From: Ken Anderson <andersonk@ae.ca>
Sent: June 20, 2025 11:48 AM
To: Boswick, Robert
Cc: Brenda Poulsen (utility@rmofgrey.ca); Genaille, Dee; Burland Ross, Siobhan
Subject: RE: DRAFT Licence - RM of Grey - St. Claude Aerated Wastewater Treatment Lagoon
Attachments: 20194231-01_St_Claude_Civil_20250617.pdf

Subject: DRAFT Licence - RM of Grey - St. Claude Aerated Wastewater Treatment Lagoon

Srips of the details we updated.

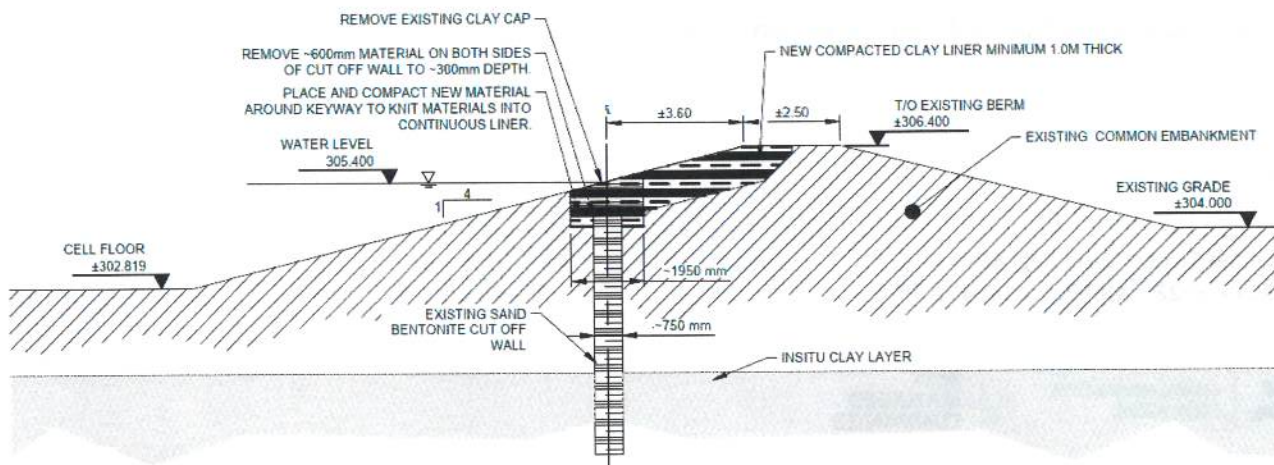
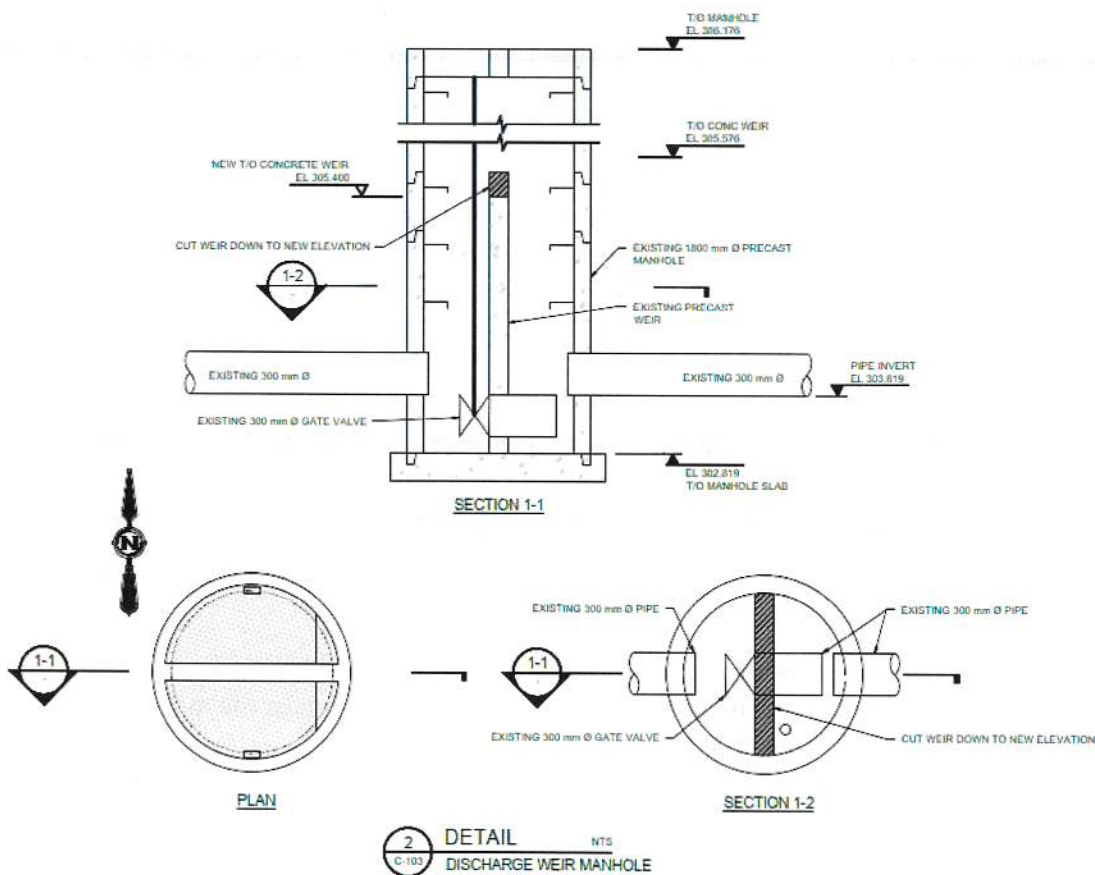
We are including in the scope of works to lower the weir in the manhole from the aerated cells to make the maximum water level in the aerated cells 305.400, to maintain the 1.0m freeboard.

We are also now including the extension of the cut-off wall to the top of the berm to provide the containment in the full freeboard around the aerated cells.

The plan below could work as long as the liquid level in the aeration cells does not then exceed an elevation of 305.400 (if the top of dyke elevation actually is 306.400).

1.0m thick clay liner around the aerated cells would be thus:

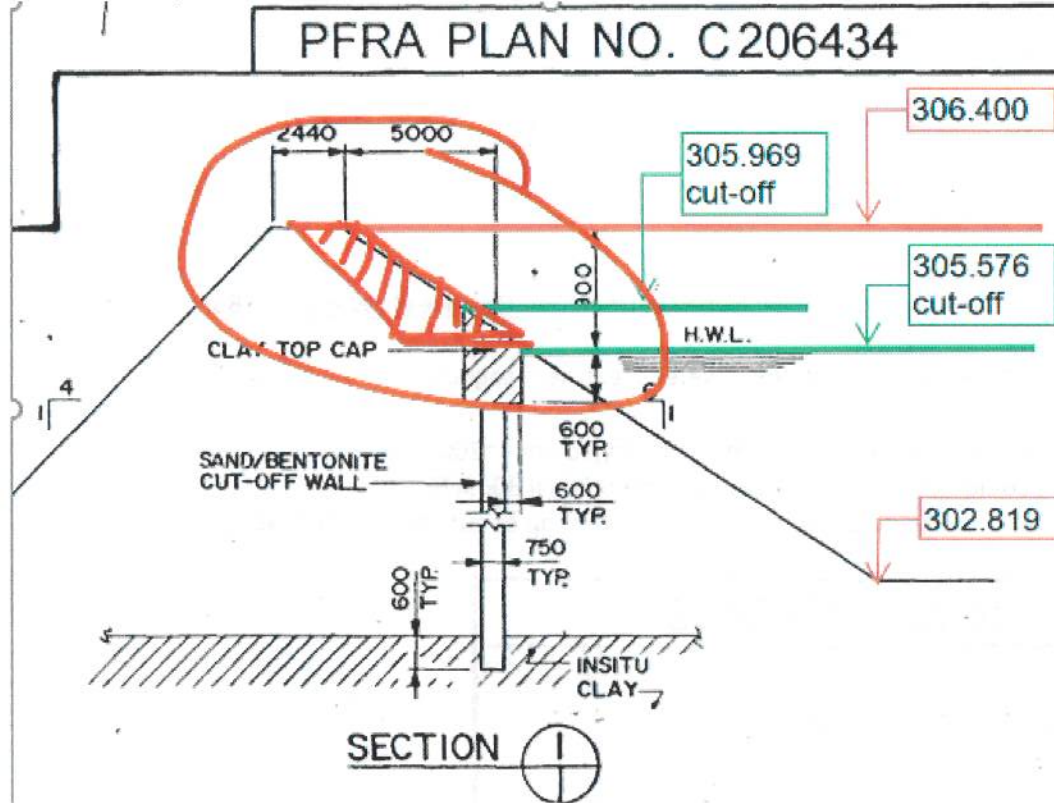
We will then have to expand the scope of works to include liner upgrades to the aerated cells around the three sides and tie this into our liner around the storage cell.

This would then make a continuous liner encasement around the perimeter of the three cells.

The detail for the liner extension would be similar to what we are doing around the storage cell, but we are not extending the berm heights (just level them off to a consistent elevation).

This should then give the 1.0 m free board that is lined with 1.0m thick clay around the interior perimeter.

I assume this then would be compliant with the updated License?

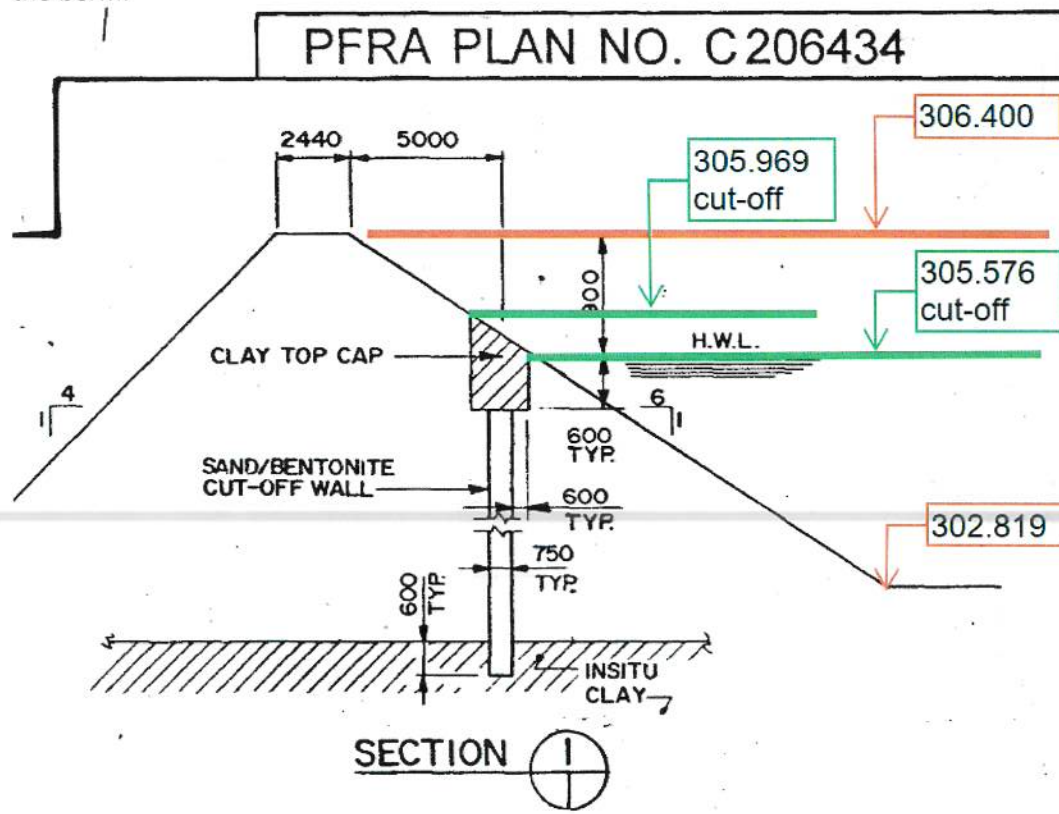
The survey found the dyke to be on average the 306.400, the top of berm ranged +or- ~200mm.

Settlement and compaction over 30 years could not show it remained at the original 306.476.

The drawings are a bit limited in details, but it makes sense your elevation of the top of cut-off does not extend to the top of the berm.

Would you be expecting us to upgrade these cells to extend the clay liner to the 1.0m free board elevation (top of berm)?

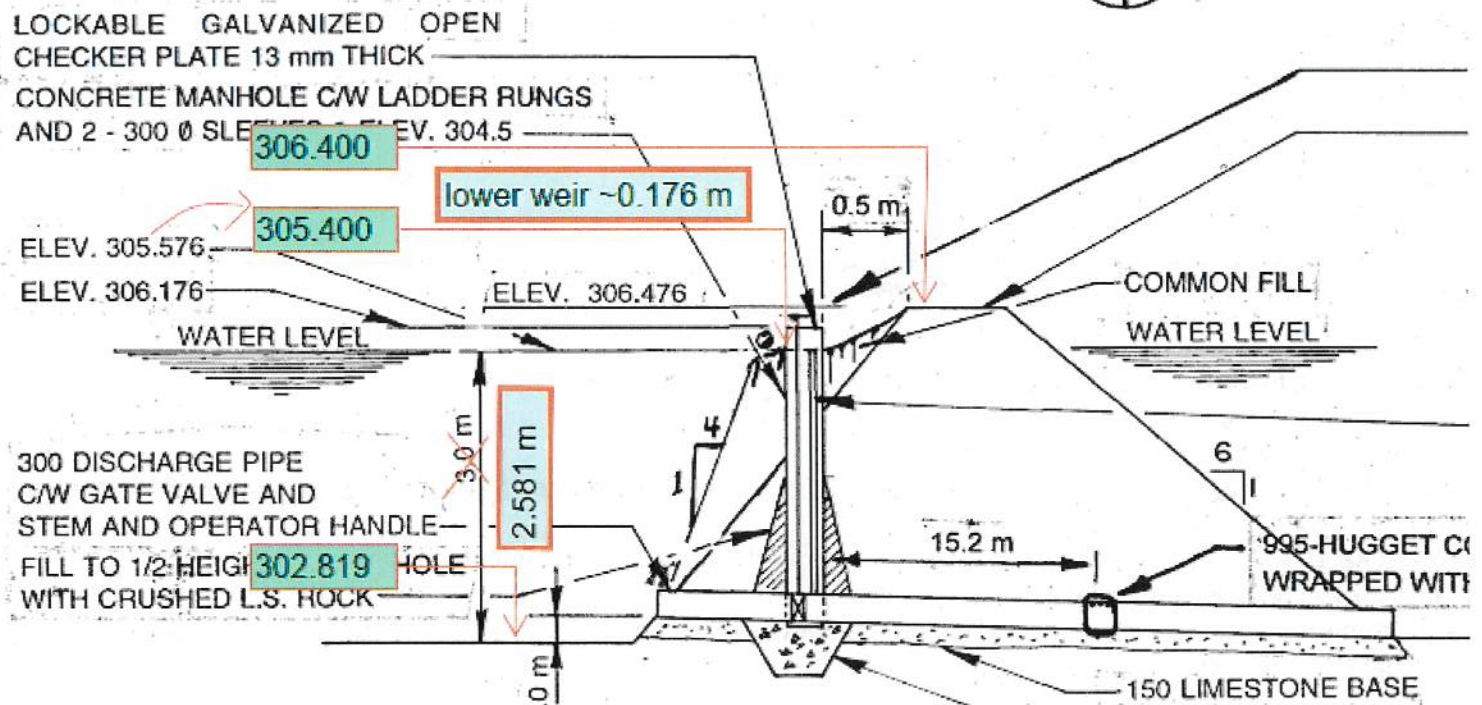
So the 3.0m liquid depth is wrong on the plans.

The correct liquid depth to use in Licence is **2.581m**.

This is based on lowering the weir 0.176 m to go from 0.9m freeboard to your required 1.0m freeboard.

The water level, berm level and floor are all ok, it was that note of 3.0m liquid depth that was inaccurate.
